AIRWORTHINESS ADVICE NOTICE

TYPE AFFECTED: PIK-20 Series including PIK-20 E/EII.
SUBJECT: Miscellaneous airworthiness information.
BACKGROUND: This AN records airworthiness information which is useful to know.

SIGNED: 	For and on behalf of:		
CHIEF TECHNICAL OFFICER AIRWORTHINESS	THE GLIDING FEDERATION OF AUSTRALIA		
GFA AN 81	ISSUE: 4	12 November 2021	Page 1 of 7

Figure 1: Lever Arm Preventing Overcenter

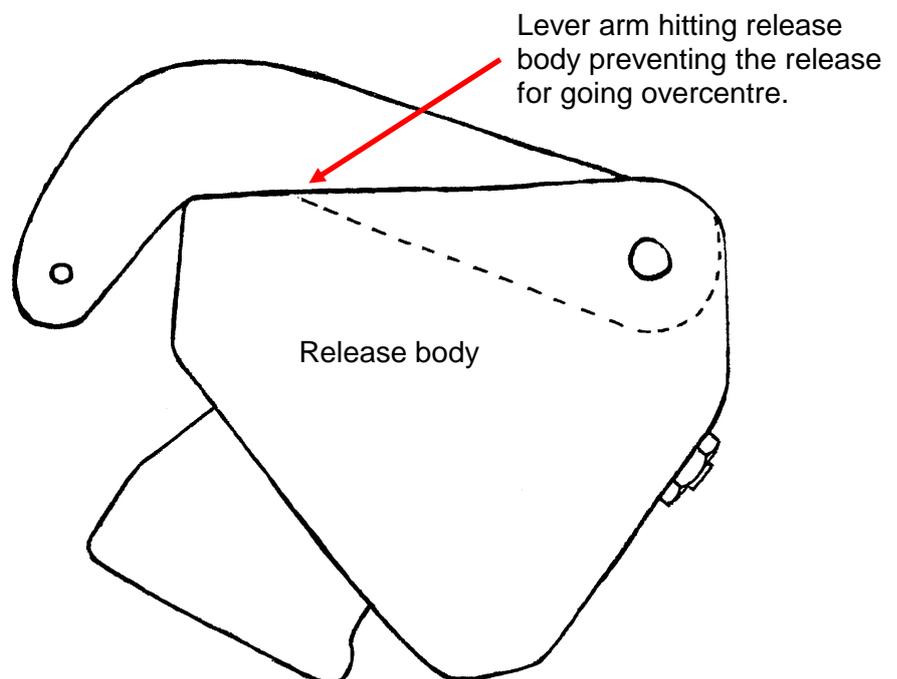
2. After adjusting the Tost release mechanism from a PIK-20D an inspector found that when the Pik lever arm was refitted to the release, it touched the back of the release body and prevented the mechanism from going overcentre.

The problem was rectified by careful removal of metal from the lever arm so that a small clearance was obtained between the arm and the release body.

Figure 2: Lower Control Column Demonstrating Interference at Cut Out

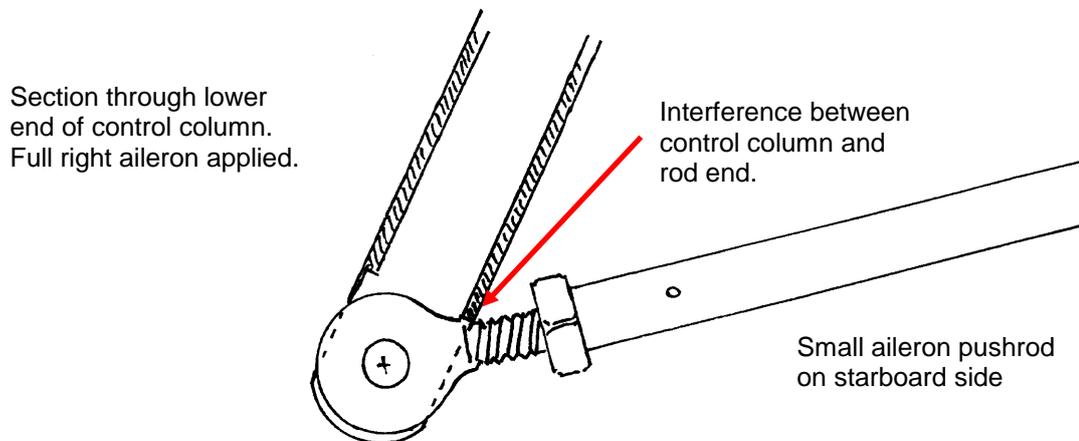
3. During the annual inspection of a PIK-20D, the lower part of the control column was found to be fouling the thread of a rod-end when full right aileron was applied.

To remedy the situation the cut-out in the control column was enlarged.

NOTE: If a rod end is found bent, it must not be straightened but replaced with a new one.

Figure 4: Detail of Cracked Spigot

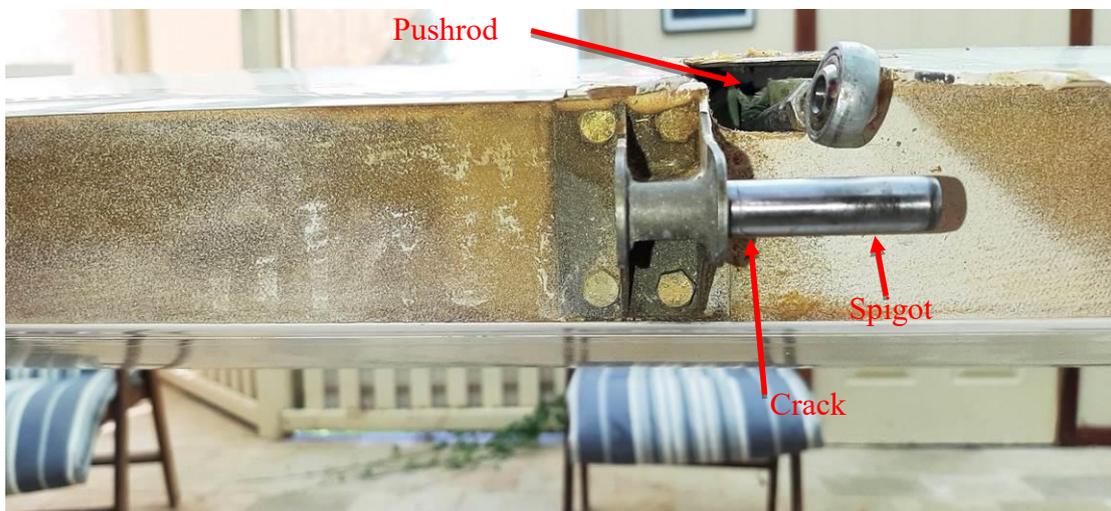
5. A Service Difficulty Report was received detailing circumferential cracking of two chrome plated flaperon pivot pin spigots on the right wing of a PIK-20E. The PIK-20 flaperon has three actuating pushrods with a corresponding spigot that forms part of the hinge. Two of these spigots on the right hand wing adjacent to the flaperon push rods had circumferential cracking (see red arrows on wing below). The cracks were only in the chrome and had not extended into the chrome molybdenum tubing. Despite this, all cracks are cause of concern and must be repaired or replaced as it is exceedingly difficult to determine the crack depth.

It appears there are three types of spigots fitted to PIK-20 variants. Some have bare chrome molybdenum spigots, others have chrome plated spigots and later PIK-20 E II variants have completely different design of chrome plated spigots. The design drawings make no mention of chrome plating. The GFA is aware of one PIK in England with similar cracking. .

If a survey or deeper inspection has not been recently carried out, it is recommended a detailed inspection be performed at the next annual inspection.
